**SITE PLAN RELEASE** (Rev. 31 of 31)

FILE NUMBER: SP-08-0510C EXPIRATION DATE: 7-26-2011

SPRING CONDOMINIUMS  
AUSTIN, TEXAS

SHEET  
03  
of  
31

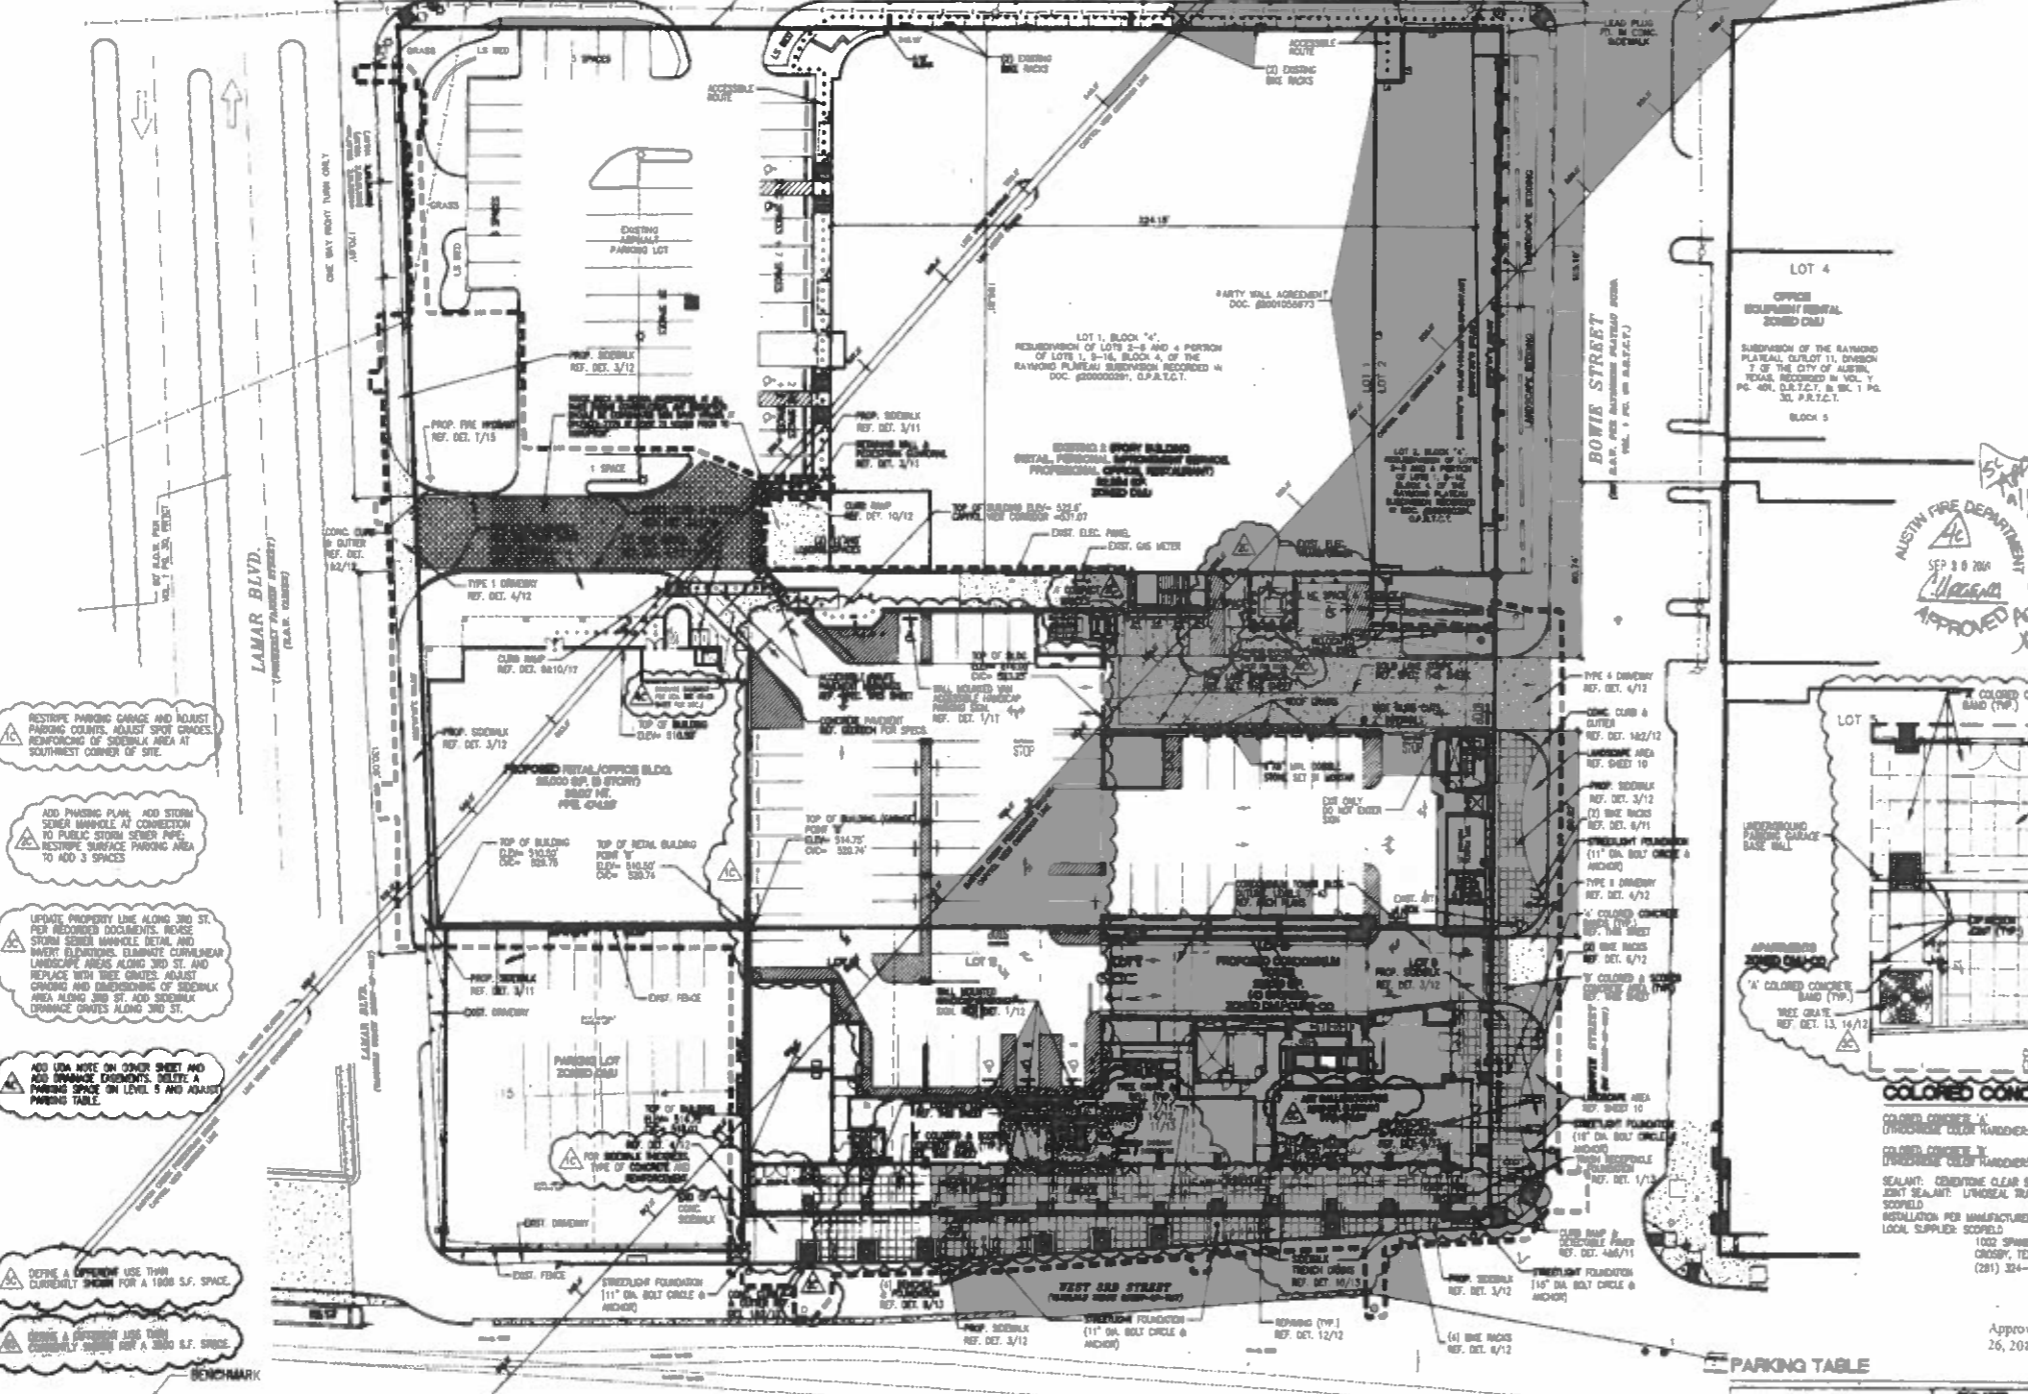
- RESTORE PARKING GARAGE AND ADJUST PARKING COUNTS, ADJUST SPOT GRADINGS, REPAIRING OF SIDEWALK AREA AT SOUTHWEST CORNER OF SITE.
- ADD PARKING PLANS, ADD STORM SEWER MANHOLE AT CONNECTION TO PUBLIC STORM SEWER PIPE, RESTORE SURFACE PARKING AREA TO ADD 3 SPACES.
- UPDATE PROPERTY LINE ALONG 3RD ST. PER RECORDED DOCUMENTS, MOVE STORM SEWER MANHOLE DETAIL AND WERT ELEVATIONS, EXISTING CURBSIDE LANDSCAPE AREAS ALONG 3RD ST. AND REPLACE WITH TREE GRATES, ADJUST GRADING AND DIMENSIONS OF SIDEWALK AREA ALONG 3RD ST. ADD SIDEWALK DRAINAGE GRATES ALONG 3RD ST.
- ADD UTM MARK ON OTHER SHEET AND ADD SPACING DIMENSIONS, DELETE A PARKING SPACE ON LEVEL 5 AND ADJUST PARKING TABLE.
- DATE IS UNKNOWN, USE THIS CURRENTLY SHOWN FOR A 1008 S.F. SPACE.
- REMOVE A PARKING JAG THIS CURRENTLY SHOWN FOR A 380 S.F. SPACE.
